Hydrol. Earth Syst. Sci. Discuss., author comment AC2
<https://doi.org/10.5194/hess-2022-328-AC2>, 2022
© Author(s) 2022. This work is distributed under
the Creative Commons Attribution 4.0 License.

Reply on RC2

Author comment on "Technical note: Validation of Aleppo pine transpiration rate measurements using the heat ratio method under laboratory conditions" by Ana M. Sabater et al., Hydrol. Earth Syst. Sci. Discuss.,
<https://doi.org/10.5194/hess-2022-328-AC2>, 2022

RC2: 'Comment on hess-2022-328', Anonymous Referee #2

Figure C1. Representation of the transpiration and environmental conditions throughout the study period. Abbreviations: REW: relative extractable water; VPD: vapour pressure deficit.

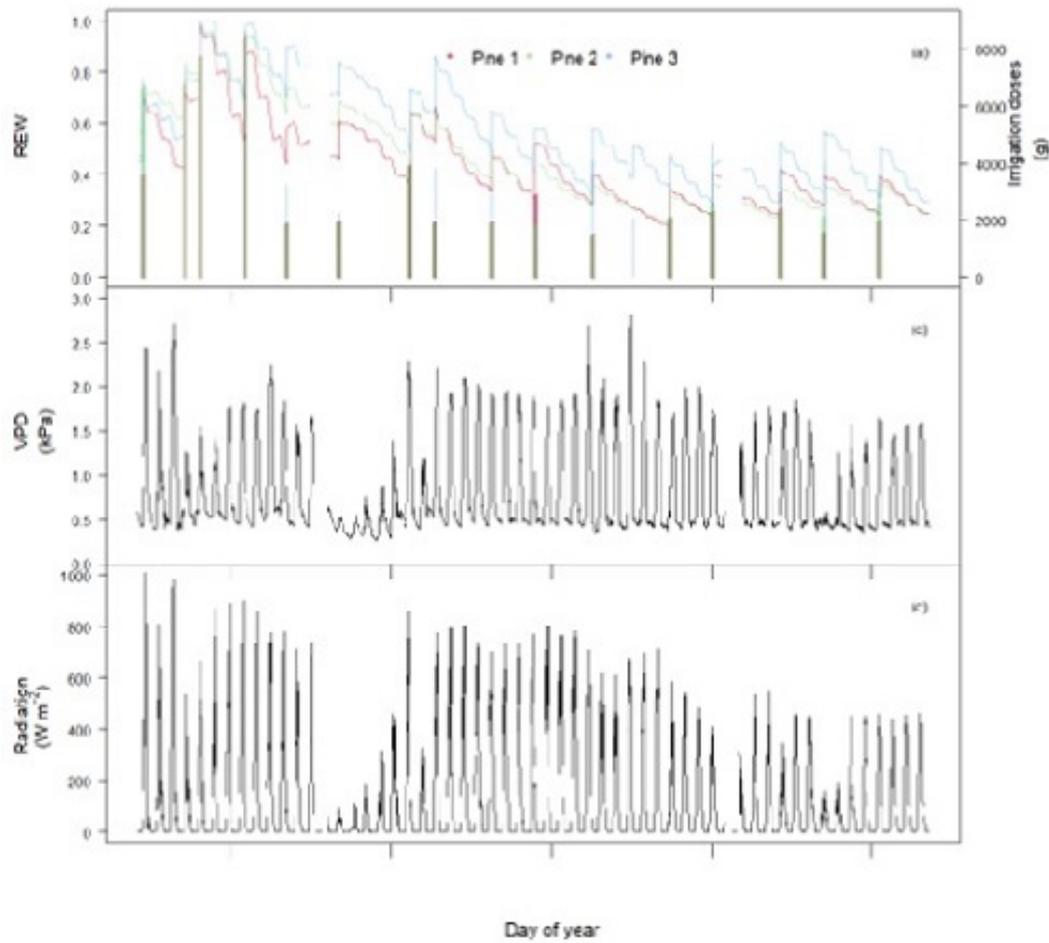
L114-116: Please consider removing this as an “auxiliary” objective and in all the related sections (Material and Methods, Results in 3.2). As with any experimental environmental study conducted under laboratory conditions, the authors should ensure obtaining representative data for the ranges of the environmental conditions to describe the expected field variations. Indeed the authors should clearly explain and describe the environmental conditions of the conducted experiment. In the Discussion, they mention that the low REW and high VPD conditions were not simultaneously achieved during the experiment. Therefore, this common drought pattern for Aleppo pine was not properly covered by their sapflow experiment (also indicated in Figure 2). Please consider removing this as an objective and better explain the environmental conditions during the experiment (irrigation doses, soil water content dynamics, solar and VPD dynamics). In addition, the transpiration relations with REW and VPD are widely described in several works for Aleppo pine under field conditions. Thus reporting them under laboratory conditions does not contribute relevant information for the subject.

However, we partly agree with the comments about the range of environmental variables. It is true that low REW and high VPD conditions, which are indeed a common drought pattern for Aleppo pine, were not simultaneously achieved during the experiment. Although it could be interesting to achieve a wide range of conditions that are more similar to field conditions, the stomatal conductance of Aleppo pine lowers, which results in a sharp drop in transpiration rates under these conditions. Low transpiration rates due to simultaneous low REW and high VPD would have not added much more information when correlating HRM and load-cells measurements, but would have been important for achieving more generalized dependence on these environmental variables. We have added some sentences in the manuscript to explicitly clarify this concept (lines 392-399).

Reply: We agree that the relation between transpiration and the environmental variables should be in the background. This was our intention when we called it an auxiliary objective, or even considering it to form part of the methodology. Thus in the new version of the manuscript, the auxiliary objective and all the related sections have been removed. Instead the environmental conditions are better described in Sect. 2.3 and also in Fig. C1 (lines 244-250). The results of the transpiration response to environmental conditions per each tree are now in Appendix D. These last results responded to Referee 1 to explain that although there was intraspecific variation in juvenile pines, the transpiration of all the individuals was controlled by the interaction between VPD and REW (Figure D2 and Table D2).

Lines 244-250: “The half-hourly REWs ranged from 0.14 to 1 (dimensionless), while the hourly VPDs obtained minimum and maximum values of 0.27 kPa and 2.82 kPa, respectively (Table 2, Fig. C1).”
